**To:** City of the Village of Douglas Planning Commission  
**Date:** January 6, 2023  
**From:** Tricia Anderson, AICP  
**RE:** **Douglas Flats – 200 Center Street – Final PUD Plan Review**

RE: Douglas Flats (200 Center Street)  
Engineering Review Comments

On behalf of the City of Douglas, our office has reviewed the *revised* drawings dated **December 23, 2022** and received **December 28, 2022** for the above referenced project. Our comments regarding the project are as follows: (*The original comments were from our December 16, 2022 review letter.*)

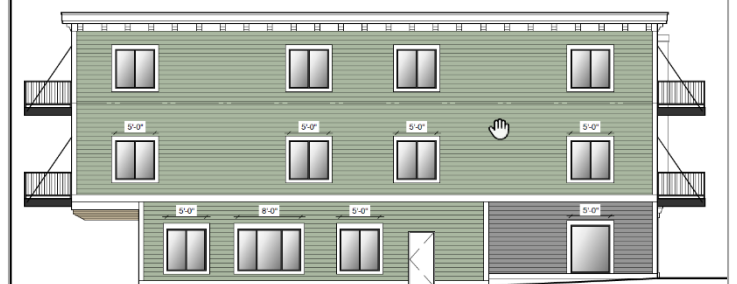
- 1. Off-Street Parking and Loading areas.** The applicant has provided parking calculations that would indicate that a total of 18 spaces are needed based on the number of residential units (containing 900 SF or less) and the usable floor area of the commercial space. The total proposed parking is 12 spaces (including one barrier-free space). The Planning Commission has discretion under Section 27.04(5) to allow for regulatory flexibility.

**Remarks:** The 12 parking spaces proposed allow for at least one space for each residential unit (10 units) in the rear of the building. The other two spaces, located as parallel spaces in the road right of way, will be used for guests and commercial space patrons. The applicant also proposes bicycle racks in the front of the building. The Planning Commission must decide if this departure “would result in a higher quality development or a better design or layout than would be possible without the modifications”. It should be noted that in the underlying zoning district (C-1, Village Center) allows a 50% reduction in required parking for by-right uses. Since ground floor residential is a special land use in the C-1 district, it would be required to provide 100% of the required spaces. Since this parcel is located within a PUD, the Planning Commission has the discretion to waive any requirement that meets the underlined criteria above. It’s important to remember that the City’s downtown is a walkable area and does attract neighborhood residents who walk or ride to their destination. The

Planning Commission should take this into consideration in determining whether to allow a reduction in parking.

PROJECT NO:  
22200138  
SHEET NO:  
C-205  
SHEET: 2 OF 6

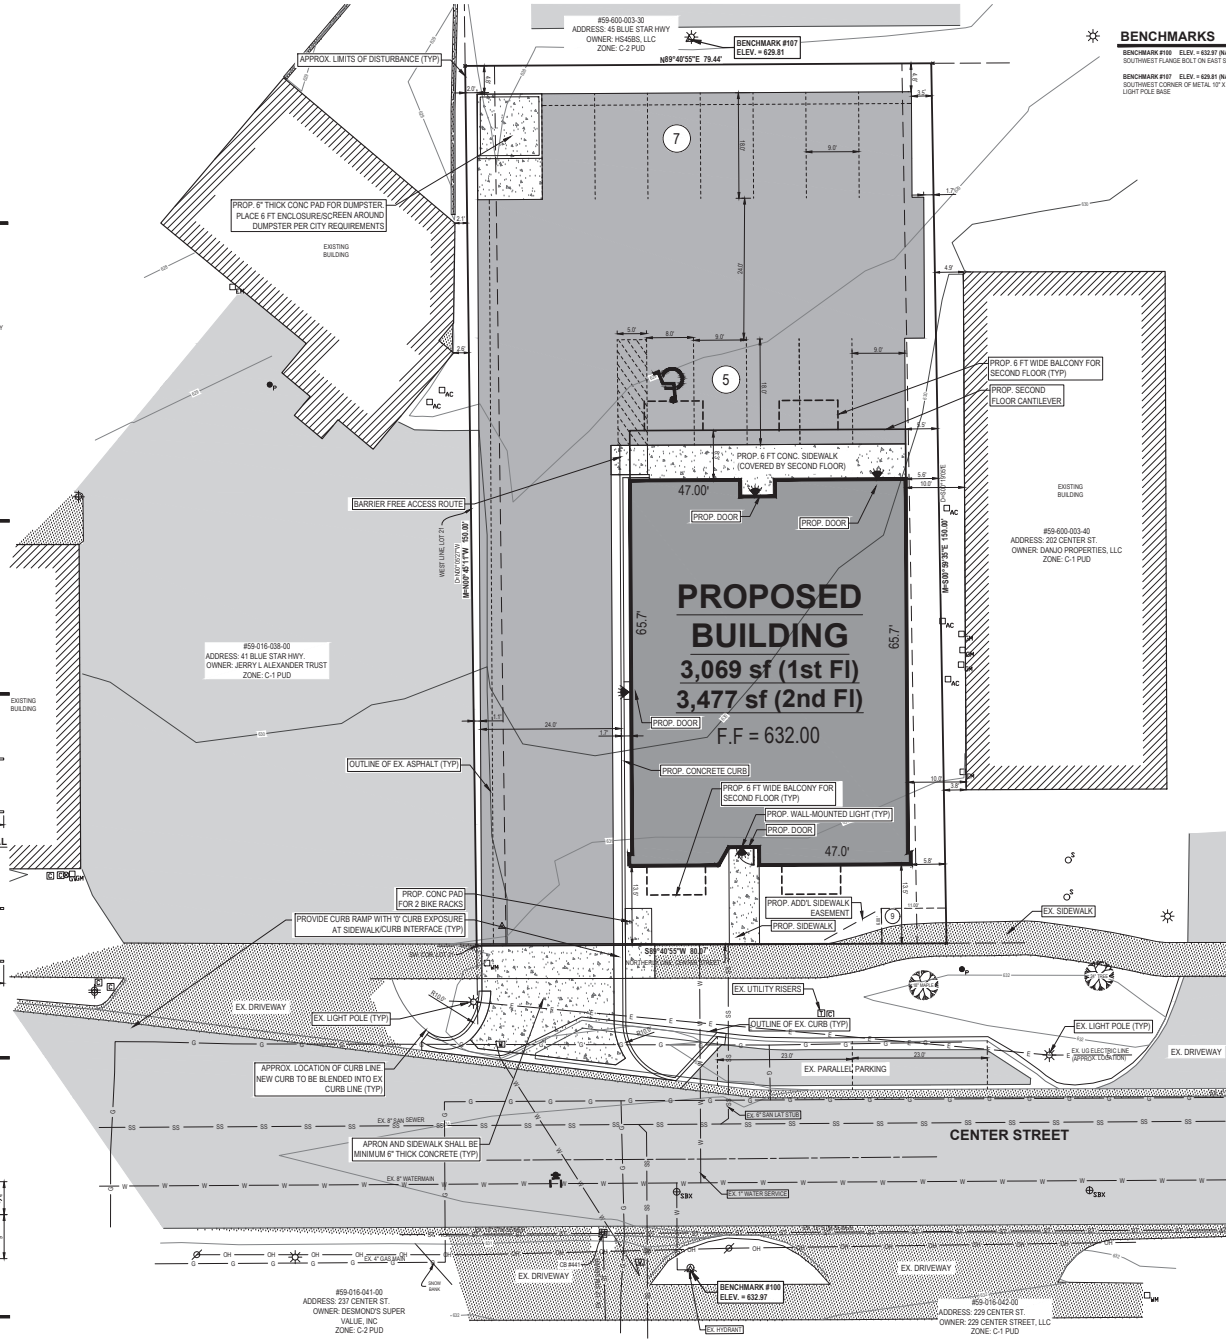
1. The proposed development includes a two-story building for residential and commercial development on about 0.3 acre site. **Information only.**
2. C-205 – Pavement markings for the parking spaces shown on the street should be included. Dimensions should be added to verify the spaces meet the City requirements. **This was added; two spaces are shown on C-205.**

3. C-205 – The existing easement for the sidewalk does not appear to encompass the sidewalk outside the right-of-way. Additional sidewalk easement should be granted. **Additional easement is shown on C-205. The easement should be similar to other agreements the City has accepted, and we recommend this be completed prior to occupancy permit being granted.**

4. C-205 – Radius dimensions should be shown. It appears the proposed radius is rather tight. This would be especially true for any delivery trucks. **Turning template overlay for an aerial fire truck was provided. Normally we would ask for a minimum of 25' radius; for this site that would not fit due to the property corner. We suggest requiring 20' radius to help the vehicle movement. Please note that light pole will need to be moved in either case as we recommend that there is a minimum of 2 feet of clearance from the back of the curb.**

5. C-205 – The concrete drive and sidewalk in the right-of-way should be 6 inches thick as there will be commercial traffic. **This is noted on C-205.**

- 1). The building is actually three stories tall.
- 2). The pavement markings/parking is now shown on the plan. As shown, the parallel spaces would be 23 ft long.

- 3). I illustrate where the sidewalk easement could be added/expanded to include the existing sidewalk that is not already in an easement.
- 4). I added dimensions on the radii. I slightly increased the exit radius to the west. I have them drawn at 10 ft now, which is rather tight. But it is not envisioned that there will be a ton of traffic here, and keeping the 10 ft radius allows two parallel spaces to remain on Center Street.

- 5). I added a note stating that the concrete apron/sidewalk shall consist of 6" thick concrete.
- 6). It is understood that ACDC will have to review/approve the drainage. This will be worked out/fully designed pending preliminary approval of the project by the city.

**SHEET NO:**  
**C-400**

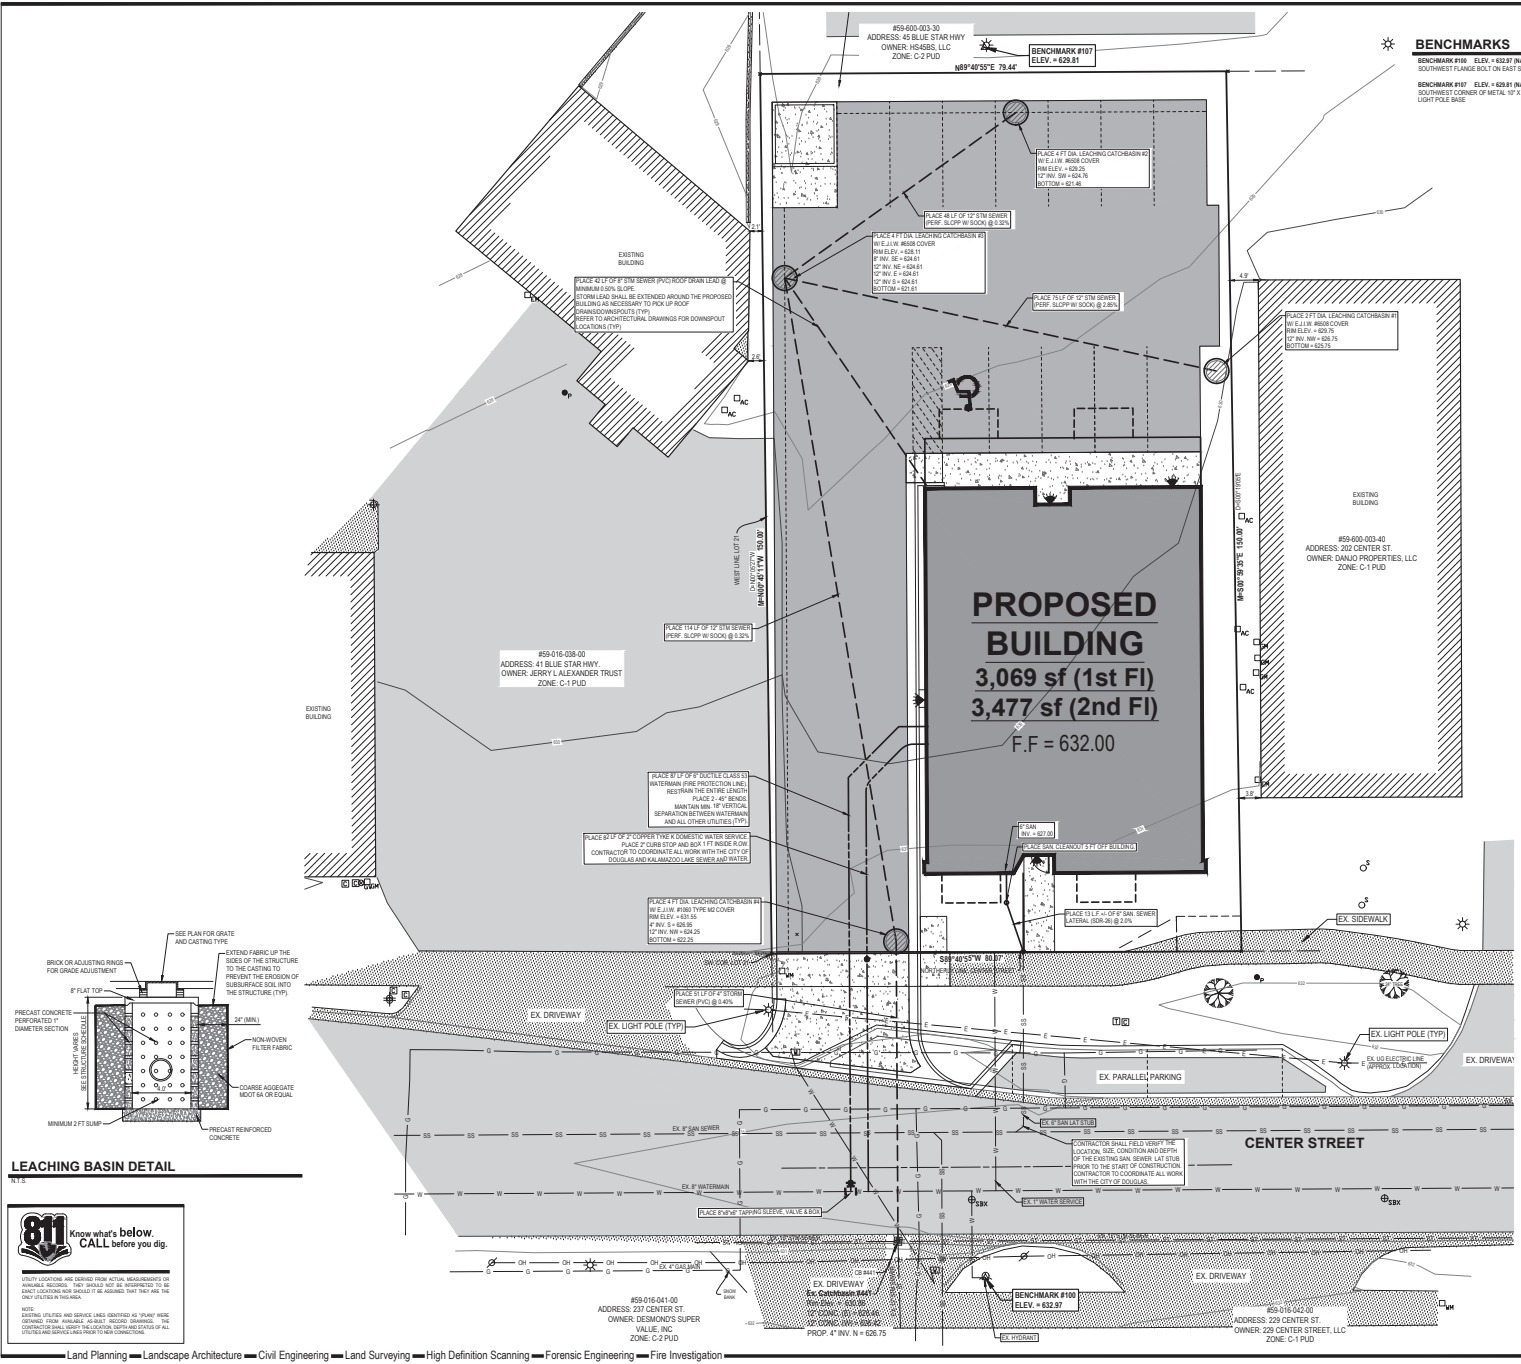
6. C-400 – All storm sewer shall be reviewed by Allegan County Drain Commissioner's office and meet their standards. **Storm sewer has not been fully reviewed as this has not been submitted to ACDC's office for review yet.**

7. C-400 – If the water service is determined to be lead/galvanized it must be replaced back to the main. A 1” service does not seem large enough for this project. Applicant should consider a 1-1/2” or 2” service. Is there a need for a fire line to this building? ***C-400 shows a new 6” fire line and 2” water service. The existing 1” water service will need to be removed at the main.***

***Based on records received from KLSWA, the water service servicing 41 Blue Star Highway from the right-of-way to the building may still be galvanized. Because the new driveway will be over a portion of this service, the service should be replaced at the time of this project if found to be galvanized.***

***The water depth will need to be field verified is the storm outlet stay as proposed as it may be in conflict. A note should be added to the drawings to field verify.***

***Metering for the building should be reviewed with KLSWA.***

8. C-400 – Because there is commercial portion to the building, consideration for a possible grease trap and/or monitoring manhole shall be consider if the use requires it. ***This should be noted in any approvals that this may be a future requirement.***
9. This should be reviewed by KLSWA and the Fire Department.
10. The developer is responsible for all review fees.
11. The developer is responsible for obtaining all permits required for this project.

- 3). We are now proposing a new water service and fire protection line. It is understood that if the existing 1" service is disturbed, it may have to be abandoned/removed at the main if it is lead/galvanized.

- 10). The building must be sprinkled. For now, I'm showing a 6" line on the plan, but the fire protection designer/plumbing engineer will have to verify the size/pressure.

- 11). I currently show a new 2" domestic water line to the building. The plumbing engineer will need to verify the size.
- 12). The fire department mentioned a fire truck has a 28 ft inside radius and that the drive entrance curb radius is likely too sharp. I modified the west radius to be 10 ft. I had mentioned we could make the radii larger at the meeting – which we definitely can if required. But doing so would result in only 1 parallel space on Center instead of 2. In thinking more about this, though, the fire truck can swing a bit onto Center Street, so it seems like they could fairly easily make the turn as is. I have attached a 'truck maneuvering' plan showing a truck with a minimum 28 ft inside radius – to show how the vehicle could enter/exit the site okay.

- 7). Okay on the water service. As mentioned above and at our meeting, new services will be provided to the building.
- 8). Per the owner, he is not anticipating any sort of use that would require a grease trap. Therefore, he would like to avoid installing one at this time.

**4. West Elevation**

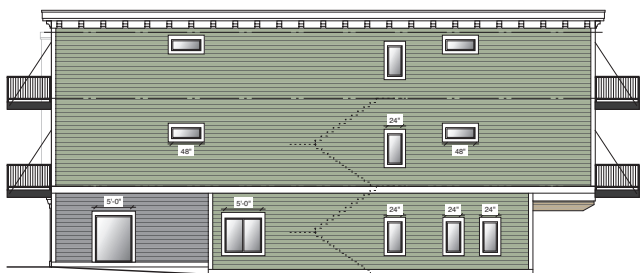
**2. Building Height.** The applicant requests that the Planning Commission allow a height of 33' to the top of the parapet to align with the mixed-use building located at 150 Center Street (just east of the subject site). Article 27 requires that the base regulations from the underlying zoning district shall be met, but as noted above, there is room for regulatory flexibility. Section 27.04(2) indicates that the proposed development must be compatible with adjacent uses. See below:

**Remarks:** The mixed-use building located at 200 Center is also zoned PUD. It would appear that the Planning Commission approved the height of this building. The vertical mix of uses and the architectural character of this building appear to fit the intent of the C-1, Village Center district. The proposed building is similar in architecture and height with 3 stories proposed. The Planning Commission should take into consideration the language of 27.04(2) in exercising its authority to waive applicable base regulations, per Section 27.04(5). In our view, the proposed building height and architectural style is compatible with the surrounding development along Center Street, particularly with the development at 150 Center Street.
